## Application for Variation of an Environmental Permit

# Hong Kong Offshore LNG Terminal Project

Proposal for Two (2) Jetting Machines

Proposed variation to the number of jetting machines during construction

Day 45 - Jetting Machine 1 & 2 Processing (~ End Oct 2021 tentative)

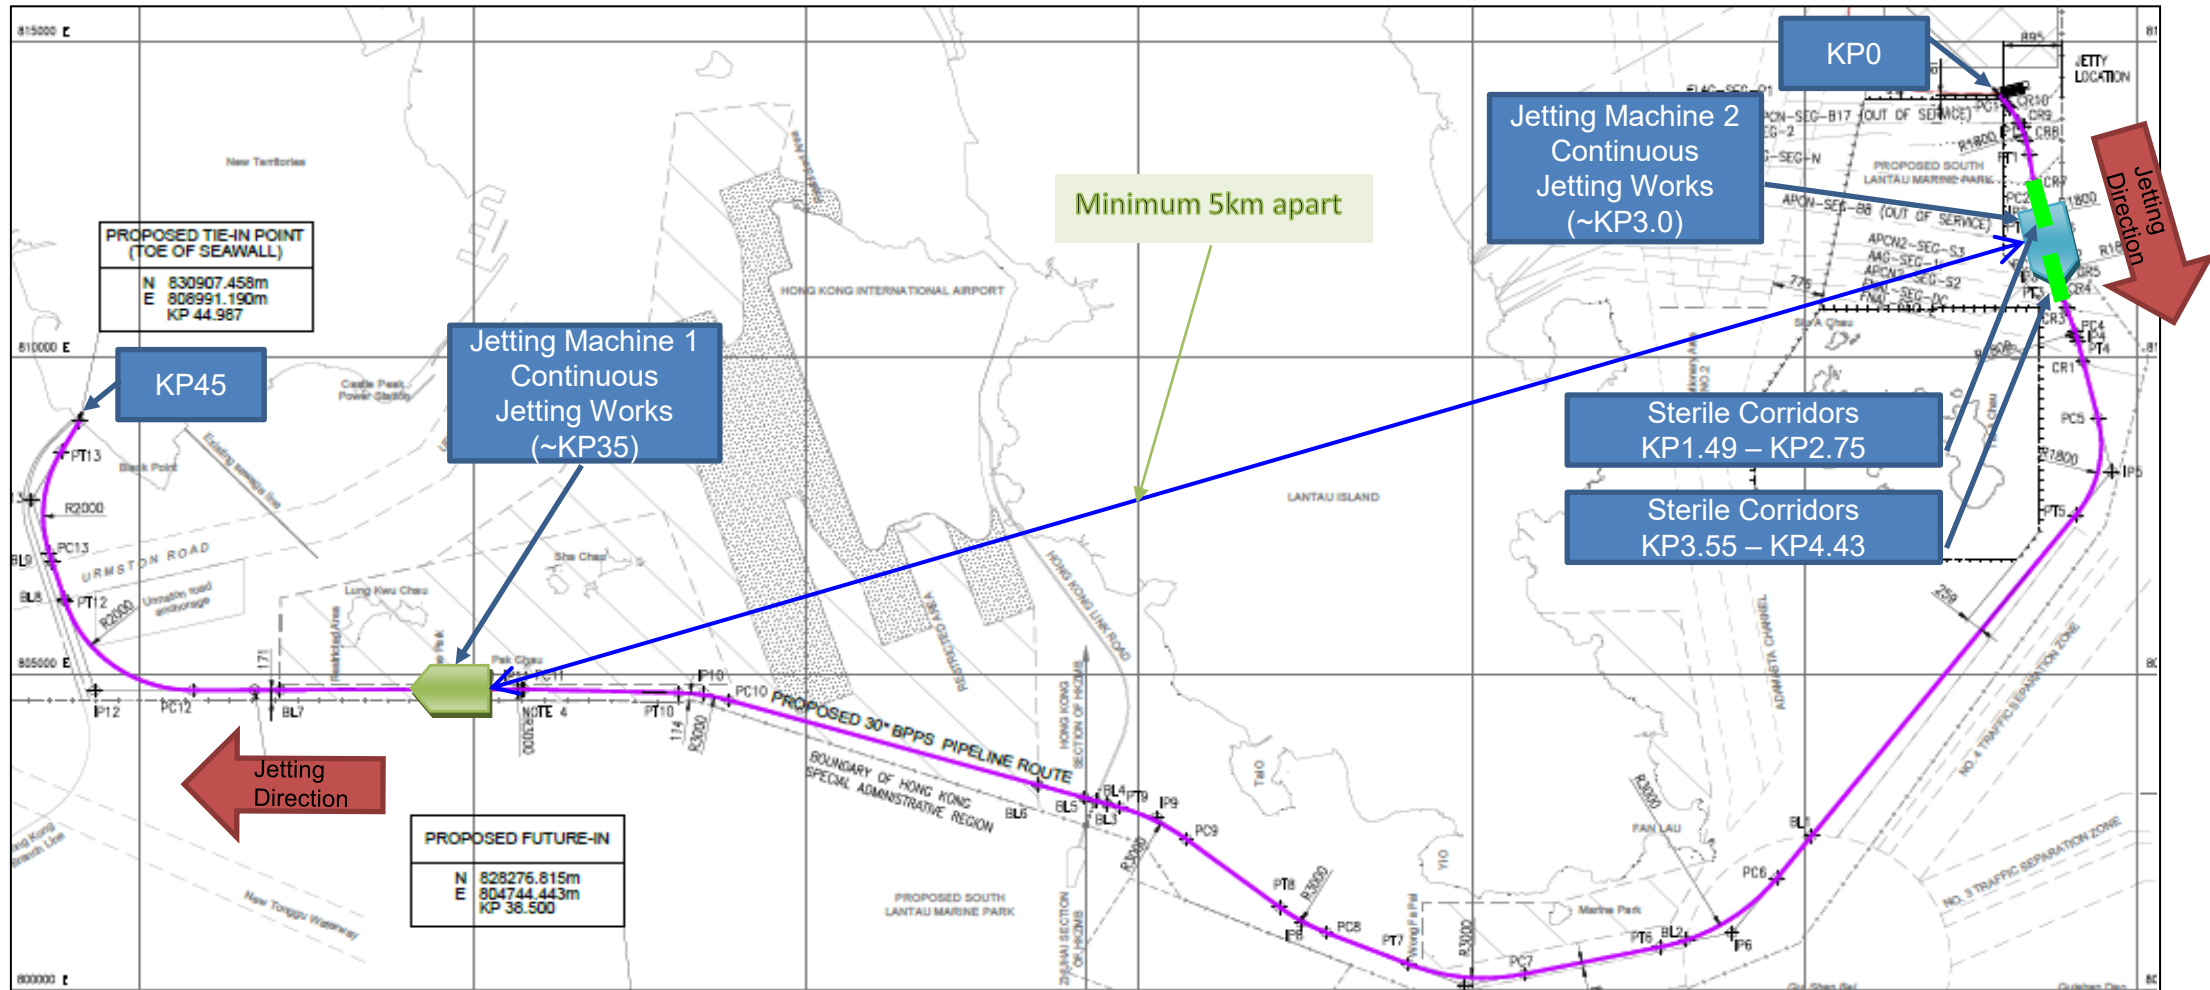
- Scenario 2: Jetting Machine 1 starts at KP26.2 and Jetting machine 2 commences at KP 0.0 and operates in the same direction (see Slides 11 - 14)
  - While both jetting machines will be jetting in the same direction, the separation distance of the two jetting machines will be maintained at least 5km apart. (see Slides 12 - 14)

- Jetting Machine 1 will not be working concurrently within KP0.0 - KP14.25 when Jetting Machine 2 is working at the subsea cable sterile corridors (i.e. KP1.49 – KP2.75 and KP3.55 – KP4.43). (see Slides 12 - 14)
